QD143-01F02 Acoustic Letter (r0).docx

PLANS AND DOCUMENTS
referred to in the PDA
DEVELOPMENT APPROVAL

Approval no: DEV2021/1251/3

Maroochydore Private Hospital - Acoustic comments for re-location of generator

Figure 1 – Generator plantroom floor plan ground level

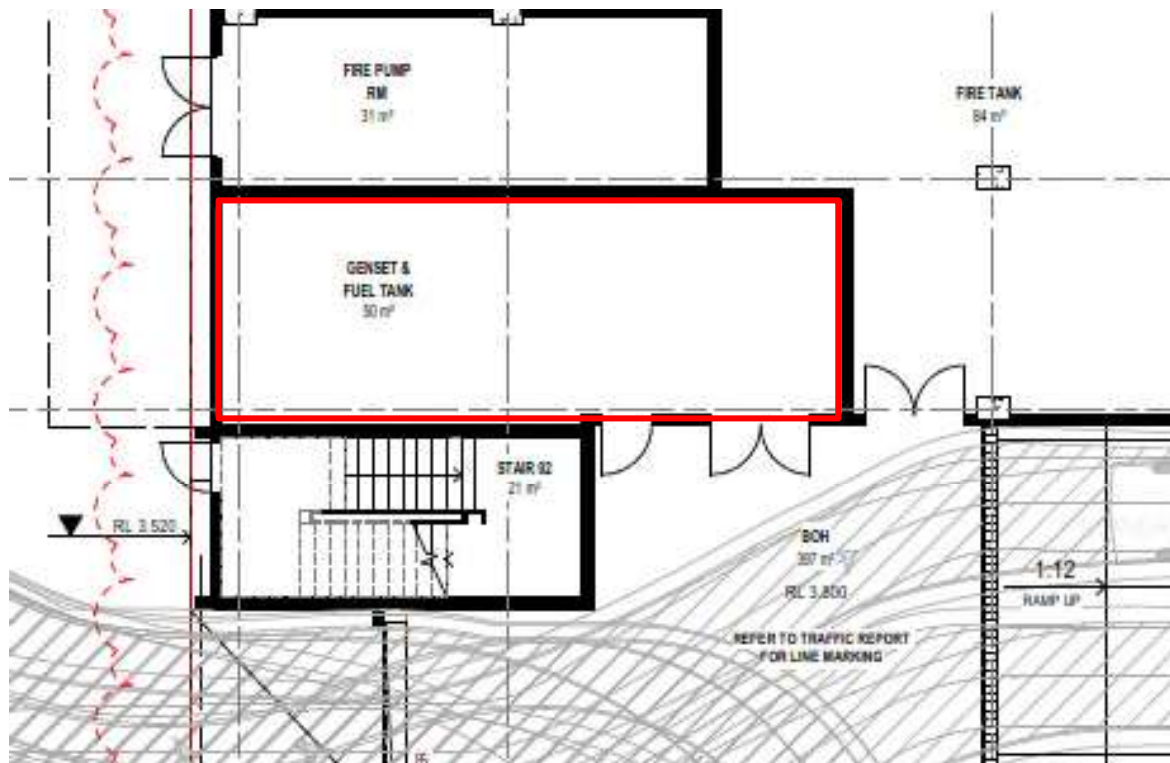
We have reviewed the location of the generator plantroom.

The previous rooftop design was based on a packaged generator unit open to the atmosphere. The generator to be housed within the ground level plantroom will most likely be selected as an unpackaged unit.

Based on our past experience with generator plantrooms we envisage the following noise control treatment will be necessary:

1. Air discharge attenuator or silencer

2. Air intake attenuator or silencer
3. Residential class muffler
4. Acoustic rated doors
5. Absorptive lining to the plantroom soffit and walls.

The model, type and size of the attenuators or silencers and other treatment can only be recommended once the actual generator model and type is selected by the electrical engineer.

Once the generator model and associated noise data are known we shall conduct noise emission calculations to confirm the five noise control items previously listed.
